CHANGE NOTICE

Log Number: EU-08-404

Part Description: Safe-T-Temp 5 Cam Timer - (Standard New Feature)

Model Affected: CMA-180

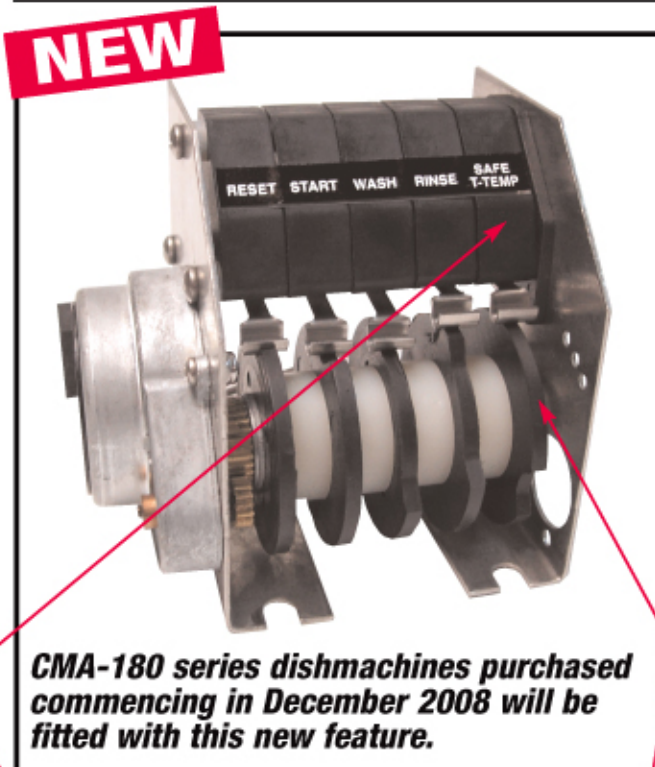
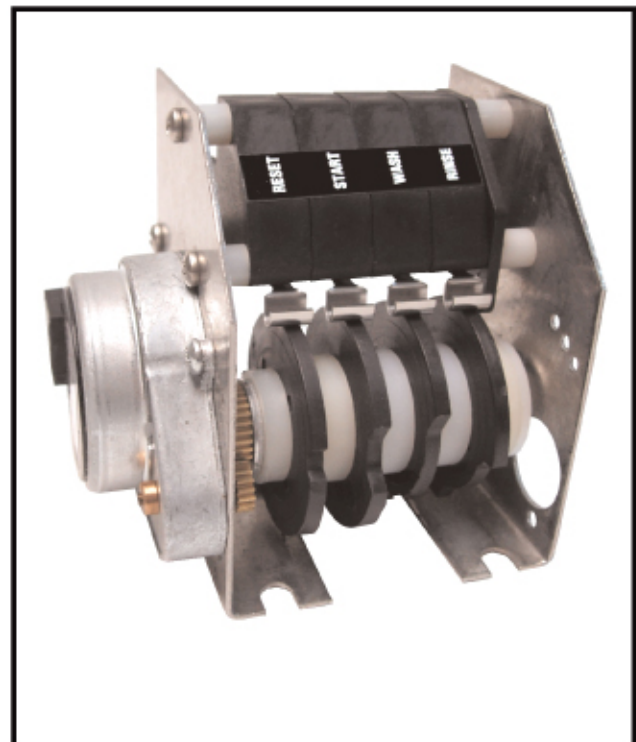
NEW 5 Cam Safe-T-Temp Timer (409.81)
Timer will pause and machine will remain in wash cycle until booster heater reaches 180°F; then it will advance into a rinse cycle. This will assure the equipment operator that the final rinse temperature will be a consistent 180°F every cycle.

Present 4 Cam Timer (409.17)
Standard CMA-180 60 second timer.

For field installation kit, order PN 17525.00, which includes installation instructions.
